**PLANNING COMMISSION AGENDA**  
**JULY 18, 2019 – 6:30 P.M.**

**La Vista City Centre Theater Preliminary Plat**

## **Comment Response: Preliminary Plat-Final Plat Theater**

## **Comment Response: Preliminary Plat-Final Plat Replat 3**

**SHEET**  
**C1.1**

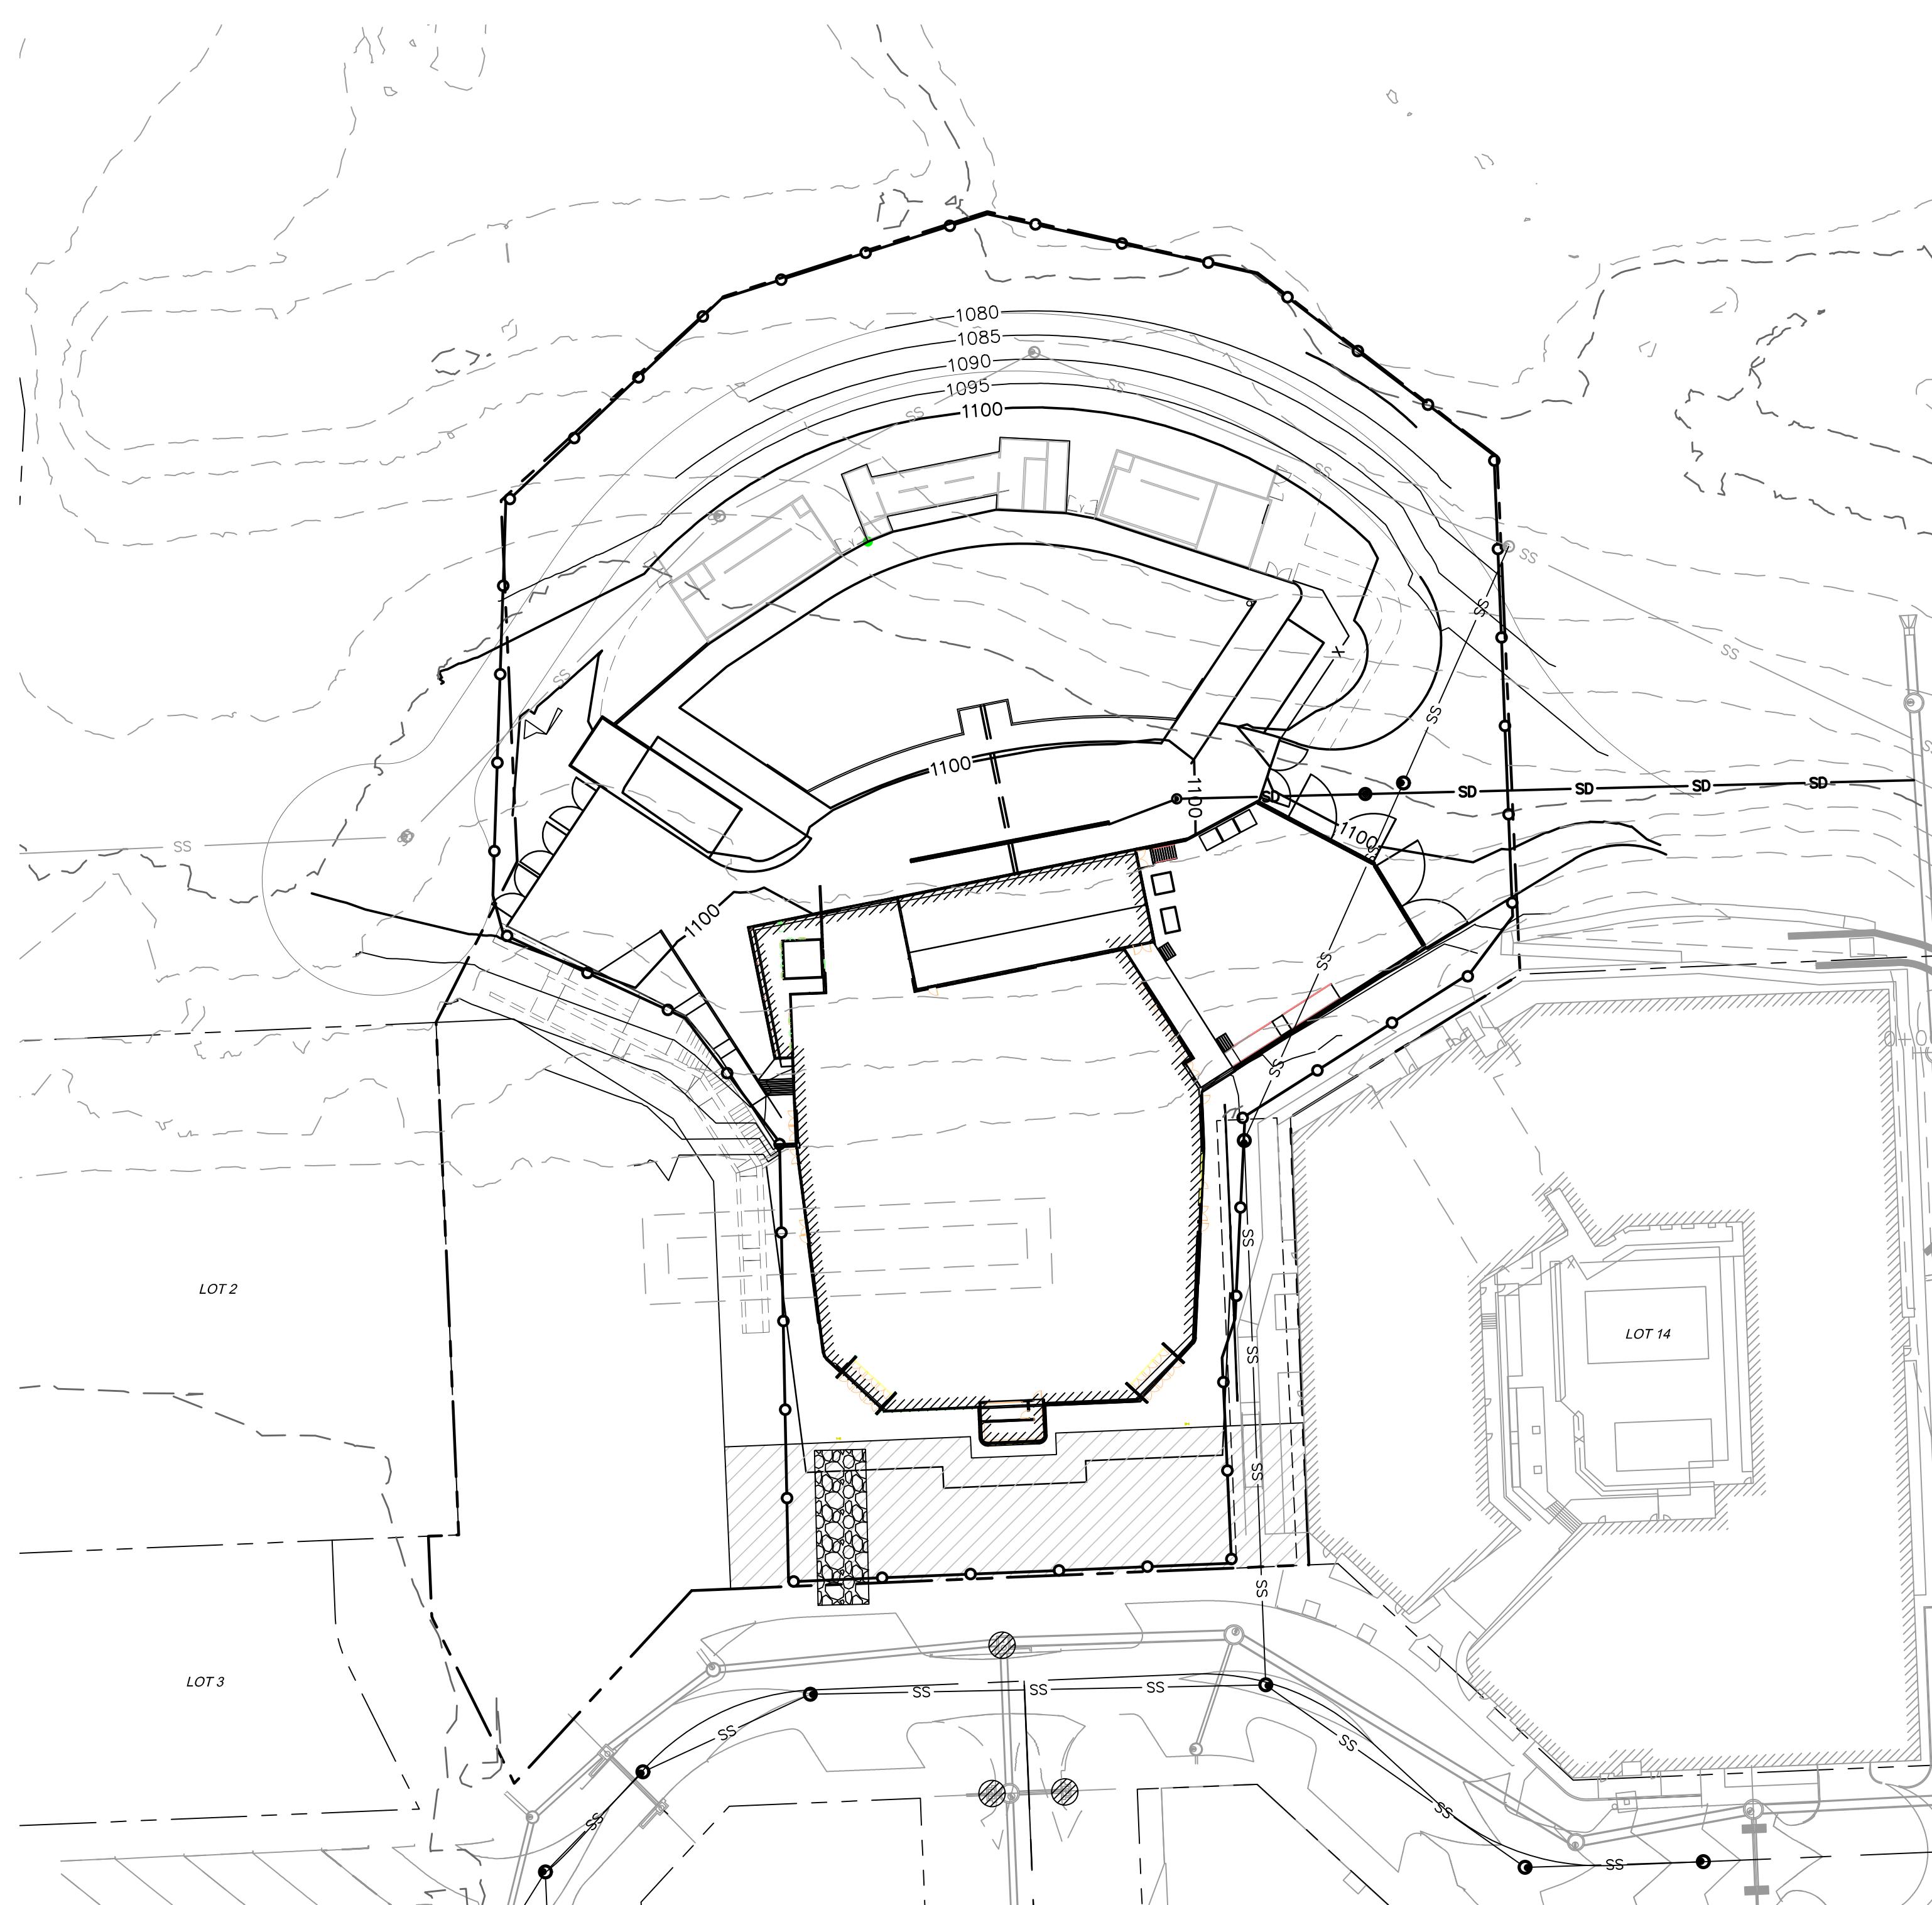
1. Article 3.03.02: Due to the nature of this preliminary plat please include proposed floor elevations on Lot 14 and on Lot 1. This should include the main floor elevation on Lot 14 and the bottom floor, stage and upper floor elevations on Lot 1. **Response: Elevations have been provided.**

3. Article 3.03.07: The location of the existing edge of normal water surface in the Civic Center Park lake needs to be shown as this affects the boundary of proposed Lot 2. The location of the relocated sanitary outfall sewer north of Lots 1 and 2 should be shown. Both of these can be based on the TD2 topographic survey of the "interface" area dated January 31, 2019. If Olsson does not already have a copy of this survey, the City will make arrangements for Olsson to receive it. **Response: This was coordinated with TD2 and the boundary has been revised to accommodate the edge of waterway. Relocated sanitary sewer has also been provided.**

5. Article 3.03.10: An easement for the public sanitary sewer through Lots 1 and 2 to the outfall sewer needs to be shown. Any storm sewer easements (public or private) proposed over Lots 1 through 3 need to be shown. There should be notations in regards to any proposed blanket easements for ingress and egress amongst the lots and for public benefit. **Response: This easement has been added for the existing line through the lot.**

6. Article 3.03.12: It appears that an existing sanitary sewer easement and an existing storm sewer easement will need to be released. Please add notations indicating the intent in regards to these easements. **Response: This will be shown as released on the preliminary plat.**

LA VISTA, NEBRASKA  
06.13.19  
SHEET  
C3.1

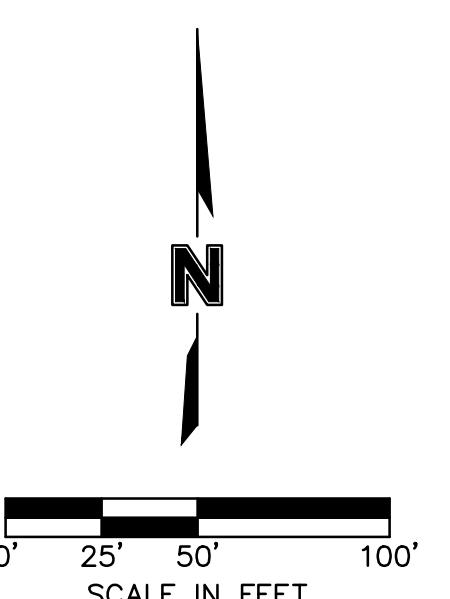
9. Article 3.03.16: On Sheet C3.1 some notations or illustrations are needed to address this requirement. The overall disturbed area will exceed five acres and add notations that sediment traps/basins, silt fences, and inlet filters will be utilized for sediment control at a minimum. Dependent on which entity undertakes the site preparation grading for these lots will identify which erosion control permit needs to be modified in Permix to include this area. **Response: Note has been added.**

11. Article 3.03.20:
  - a. Per Item 2 above, show the sanitary outfall sewer. **Response: Provided.**
  - b. The storm drainage plan (Sheet C3.1) needs to include conceptual information for proposed water quality treatment. The 2-year peak runoff increase can be addressed in the storm water detention facility in Civic Center Park. **Response: Storm quality structure has been provided.**

- c. Information concerning a PCSMP plan needs to be provided on Sheet C3.1. This would include reference to the current plan for PCSMP No. 20170324- 3736P and particularly Note 2 on Exhibit "B". Notations as to how runoff from the proposed truck dock and bus parking aprons will be treated are needed at a minimum. These locations have the most potential for pollutants that could affect the lake. **Response: PCSMP information has been added to sheet C3.1 and PCSMP # has been added. A trench drain has been added along the front of the truck dock and will tie in before the vortex system.**

SHEET  
C1.1

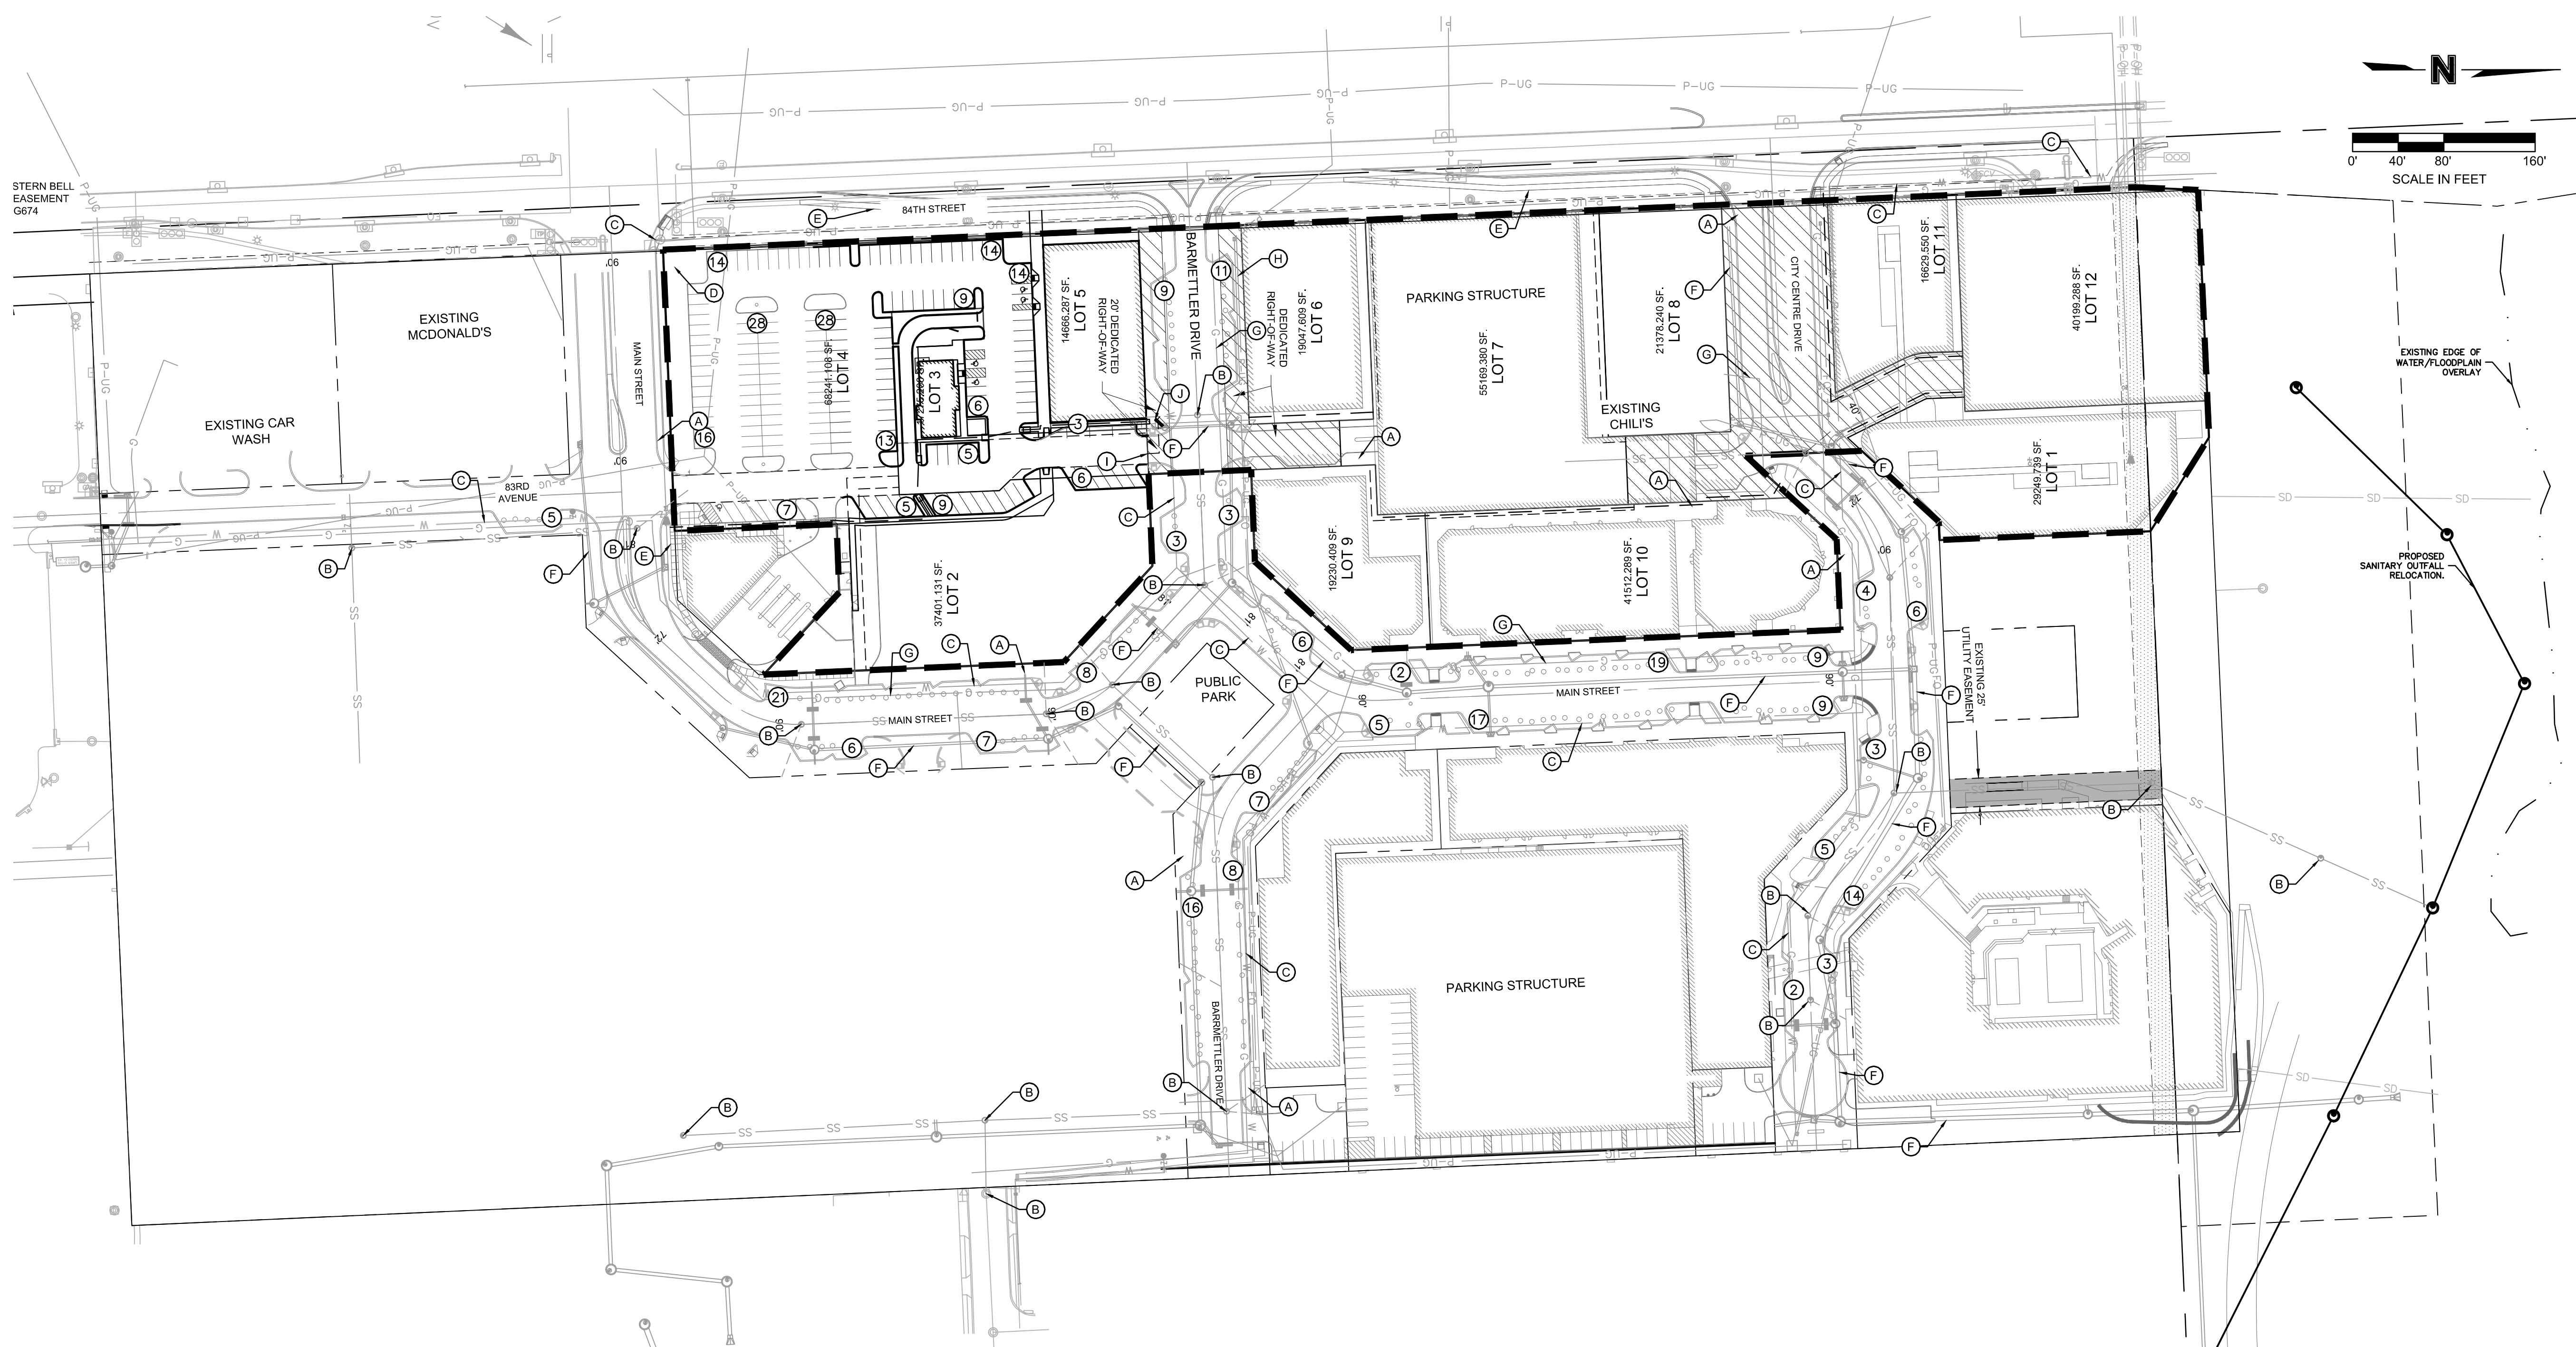
1. Article 3.03.07: Provide clarification between existing (or soon to be existing) public sewers and water mains and proposed additional public sewers and water mains. This can be done with line types and should identify additional proposed public sewers and water mains beyond what is currently contracted for Phase 1 public improvements. The sanitary sewer layout shown on Sheet C2.1 is not correct and needs to be corrected to match the public improvement plans. The location of the relocated sanitary outfall sewer north of Lots 1 and 2 should be shown based on the TD2 topographic survey of the "interface" area dated January 31, 2019. If Olsson does not already have a copy of this survey, the City will make arrangements for Olsson to receive it.

3. Article 3.03.10: In addition to comment on Article 3.03.07 identify in some manner (illustration or notation) proposed sidewalks to reach Lots 11, 5 and 2. **Response: Sidewalks are shown as part of the future development configuration. These are subject to change depending on the final lot configurations.**

4. Article 3.03.12: Identify proposed easements for ingress/egress and utilities. Examples include sidewalk over edges of Lots 7 and 8 to reach Lot 5 as well as utility easement in the same area to provide communications to the second parking structure. Also, any easements needed to accommodate street lighting cables, conduit and service panels (such as over part of Lot 12) need to be addressed. Any blanket ingress/egress easements should be noted. **Response: Easements have been provided for access and utilities as well as ROW areas have been provided for the entrance to the garages to accommodate the planned sidewalks for these entries. Utility easement for Lot 12, has been added to accommodate the conduit and service panels.**

9. Article 3.05.09: Identify the square footage of each lot, not the acreage. **Response: Lot areas have been revised to SF as requested.**

**Response: Sanitary and storm mains for the development have been installed throughout the project and the plans have been updated to reflect what was installed with the public improvements including the stub locations for the lots. The outfall sewer north of the lots have been added and coordinated with TD2 and provided on the plans.**
